საგანი: სს „კავკასიის ქარის კომპანიის“ პოზიცია საზოგადოება ბუნების  
კონსერვაციისთვის - საბუკოს და „Birdlife International“-ს მიერ სამინისტროში  
წარდგენილ მოსაზრებებსა და შენიშვნებზე

თქვენი 2020 წლის 3 ნოემბრის N10391/01 წერილის პასუხად, დანართების სახით,  
წარმოგიდგენთ, სს „კავკასიის ქარის კომპანიის“ პოზიციას „კასპის ქარის  
ელექტროსადგურის (დაგეგმილი სიმძლავრე 54 მგვტ.) მშენებლობისა და  
ექსპლუატაციის, 110 კვ ეგზ-ის გაყვანის და 110 კვ ქვესადგურის განთავსების“ პროექტის  
გარემოზე ზემოქმედების შეფასების ანგარიშზე საზოგადოება ბუნების  
კონსერვაციისთვის - საბუკოს და „Birdlife International“-ს მიერ სამინისტროში  
წარდგენილ მოსაზრებებსა და შენიშვნებთან დაკავშირებით.

საბუკოს მოსაზრებები სს „კავკასიის ქარის კომპანიის“ კასპის ქარის ელექტროსადგურის მშენებლობისა და ექსპლუატაციის პროექტთან დაკავშირებით წარმოდგენილი დამატებითი ინფორმაციის შესახებ

**Subject: Kaspi wind power station project**

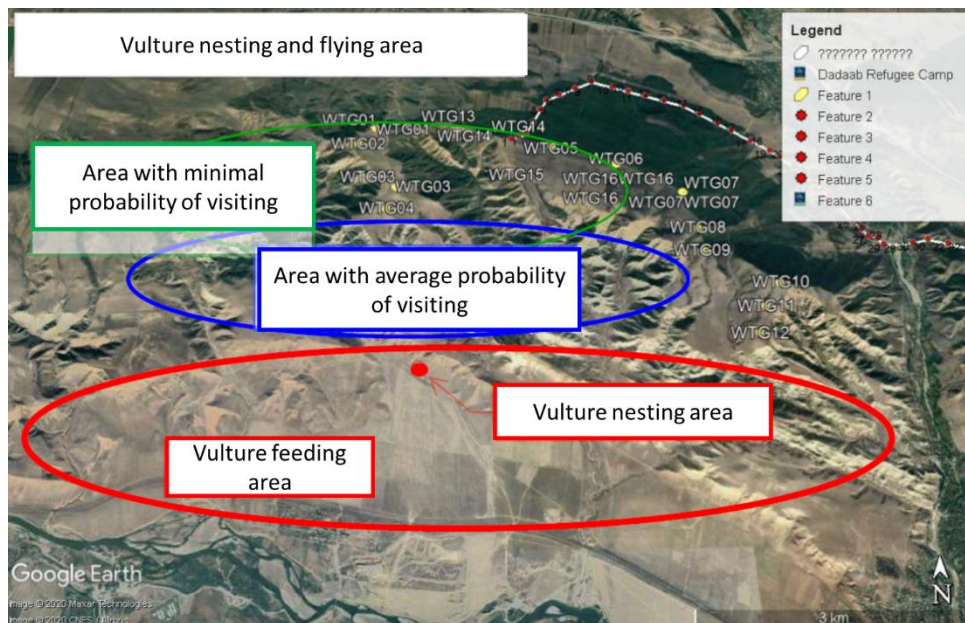
**The first and the most important issue** concerns the Egyptian Vulture (*Neophron percnopterus*), which is on the red list of the International Union for Conservation of Nature (IUCN) its status is - endangered. Besides, Egyptian Vulture is a protected species under the Second Annex to the European Convention for the Protection of Wildlife and Natural Habitats (the so-called Bern Convention) - "Strictly Protected Fauna Species," In Europe, the vulture species have declined by over 50% in the last 50 years. Most Egyptian Vulture populations are migratory. In general, large- scale threats include deterioration and loss of habitat, shortage of food through changes in land use (for example, infrastructure projects on former feeding grounds), **collisions with wind farms**.

Regarding other reasons, according to the bird monitoring studies conducted by the company experts risks seems to be lower for Kaspi Wind Farm:

- **deterioration and loss of habitat** – Vulture nest is located in 2-3 kilometers from the Wind turbines.
- **shortage of food through changes in land use** (for example, infrastructure projects on former feeding grounds) - Project area is far and at the opposite side from the vultures feeding area.

- **Collisions with wind farms** – Project area is not suitable for the vulture feeding and habitat Accordingly during 1 year monitoring experts have conducted, vultures were seen several times close to the project area (close not on the project area), and experts do not expect them to fly lower than 200-300m. Total height of the turbines do not exceed 180m. Additionally, it needs to be admitted that only 3 nests were identified close to the turbine territories, distance between the closest one is 2-3 km, while the further one is more than 10km. Egyptian vulture's global population is 12,000-38,000 mature individuals (BirdLife International, 2018a). Close to the wind farm only two individuals are nesting. Representing 0.0052% - 0.016% of population. According to the studies company has conducted, impact is expected to be low.

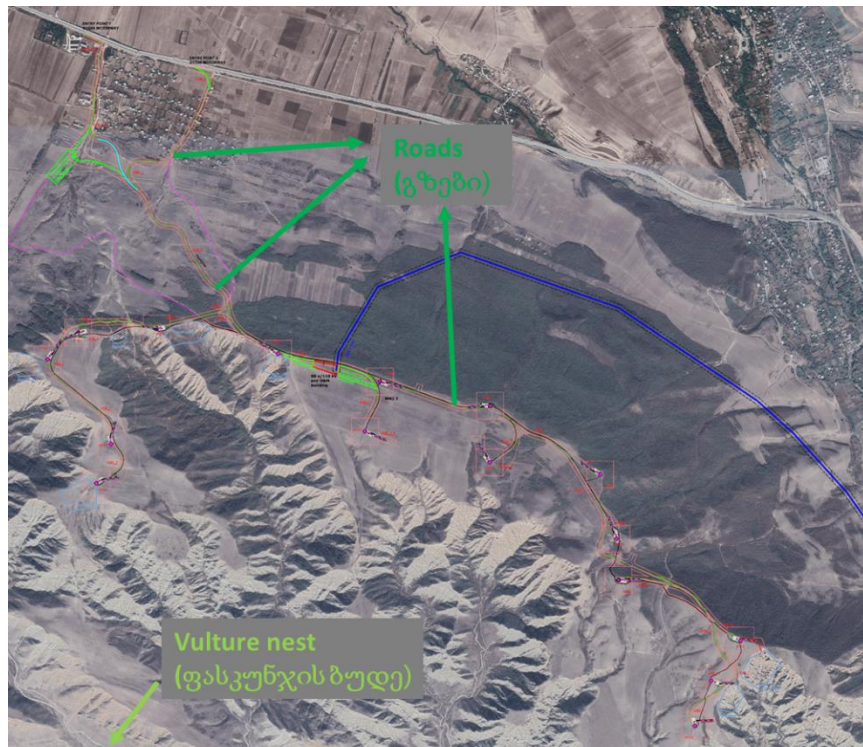
In Annex II of the European Commissions' guidance document, "Wind Energy Developments and Natura 2000" species most likely to be affected by the wind farms are listed, including Egyptian Vulture (*Neophron percnopterus*). It states that there is evidence of substantial risk of habitat displacement and barrier effect while there is evidence or indications of risk or impact for Bird Strike/Collision; they are also listed in Annex I of the EU Birds Directive. **Annex V of the same document indicates that special concern has to be raised for Egyptian Vulture in terms of collision fatalities, and birds that are making regular flights between nesting and feeding areas may face enhanced risks.**

Egyptian Vulture can fly a maximum of 25 kilometres daily to obtain food. According to the EIA report, the maximum distance between the turbines and the nearest nest is 2-3 kilometres. Between the farthest pairs is 10 kilometres. Studies from Spain have shown that inappropriately

planned wind farm developments have had significant impacts on Egyptian Vulture populations due to increased mortality.

Both nesting and feeding areas are located to the South from the project area and away from the regular flights route (between nesting and feeding areas), which is in-line with your statement and international standards, thus proves company's findings -> impact on vultures is expected to be minimal to non-existent. Vultures do not have incentive to fly at the project area. Please see the map below.

During monitoring period, the company has involved both international and local experts to conduct extensive studies and analysis. All of them concluded that EU does not set requirements for distance between a wind turbine and Egyptian vulture habitat. 15 km distance is mentioned in the article Carrete, M., et al. 2009. Article describes bird collision statistical model for wind farms in Spain. Study does not stipulate that the collision will be higher if the distance decreases. Also, there are number of studies putting this hypothesis under the question. Experts believe that each case should be evaluated separately considering wind farm location, nest location, habitat area feeding area etc. CWC has conducted more than 1 year of monitoring and evaluated vulture habitat in details. The company believes that experts conducted the studies using the best approach after the submission of ESIA reports the company has not received any complaint about the methodology of those studies. . Study was conducted by highly experienced local expert Dr. Alexander Abuladze, who is monitoring those vultures and birds of prey in Georgia since 1970s. Needless to say that Mr. Abuladze is experienced with wind farm projects in Europe as well.
